SUBJECT: ISSUANCE OF AMENDMENT NO. 116 TO FACILITY OPERATING LICENSE NPF-9 AND
AMENDMENT NO. 98 TO FACILITY OPERATING LICENSE NPF-17 - MCGUIRE
NUCLEAR STATION, UNITS 1 AND 2 (TACS 77558/77559)

SAFETY EVALUATION BY THE OFFICE OF NUCLEAR REACTOR REGULATION
RELATED TO AMENDMENT NO. 116 TO FACILITY OPERATING LICENSE NPF-9
AND AMENDMENT NO. 98 TO FACILITY OPERATING LICENSE NPF-17
DUKE POWER COMPANY
DOCKET NOS. 50-369 AND 50-370
MCGUIRE NUCLEAR STATION, UNITS 1 AND 2

FIGURE 2.1-1

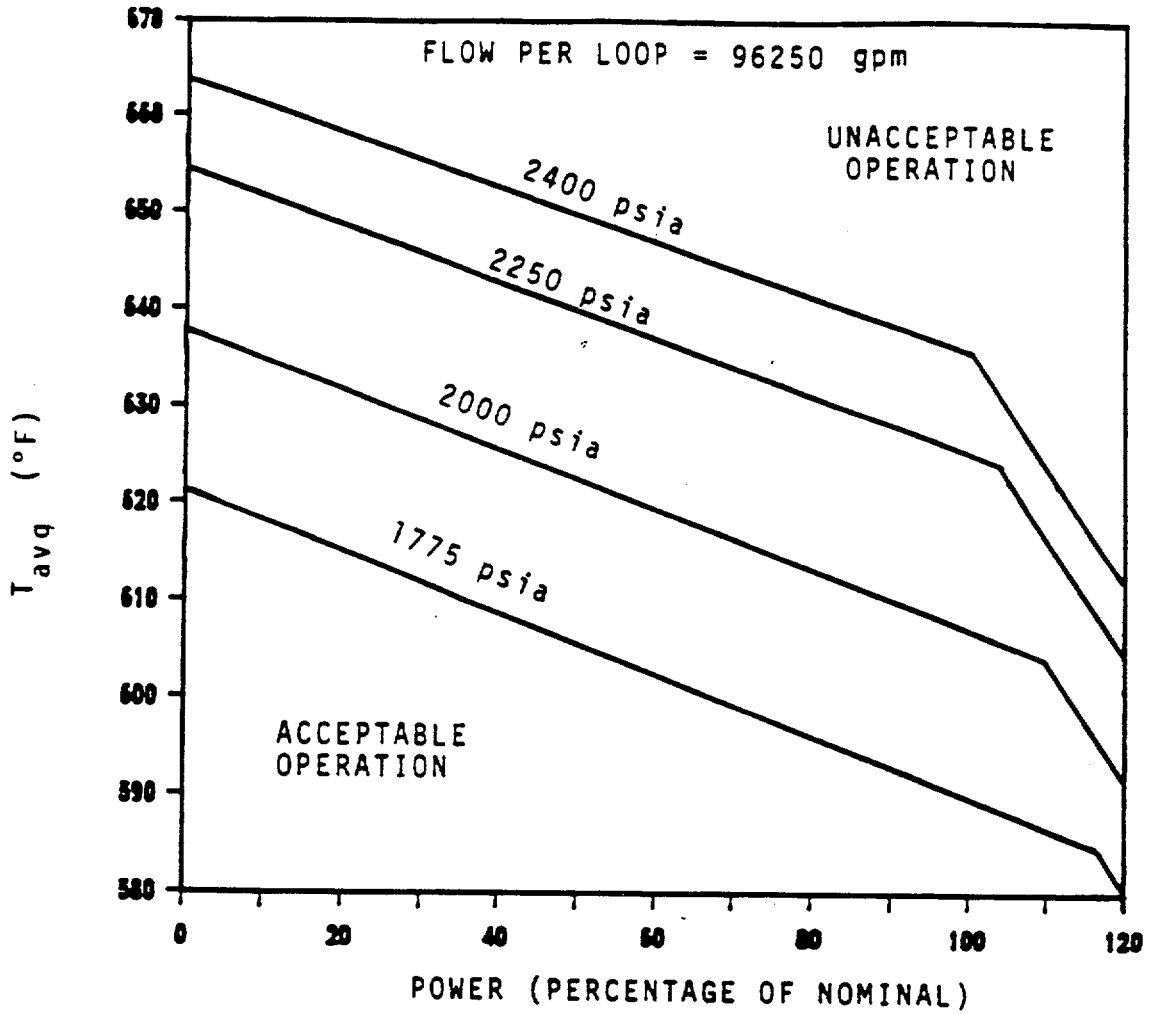
In its September 4, 1990 submittal, the licensee evaluated the impact of operation at one percent reduction in minimum measured flow on thermal margin. The reduced flow rate resulted in a slight reduction in core departure from nucleate boiling (DNB) limits. Consequently, the licensee developed revised core safety limits for average RCS temperature as a function of power for the reduced flow rate. These revised limits are identified in a proposed TS Table 2.1-1, "Reactor Core Safety Limit - Four Loops In Operation." The flow per loop identified on proposed Figure 2.1-1 is 96250 GPM, which is the minimum measured flow (MMF) rather than the thermal design flow (TDF). The MMF differs from the TDF by an amount equal to instrument uncertainty. For consistency, the terminology in TS Table 2.2-1 is changed from "design flow" to "minimum measured flow" when the loop flow of 96250 GPM is identified. These changes are acceptable.
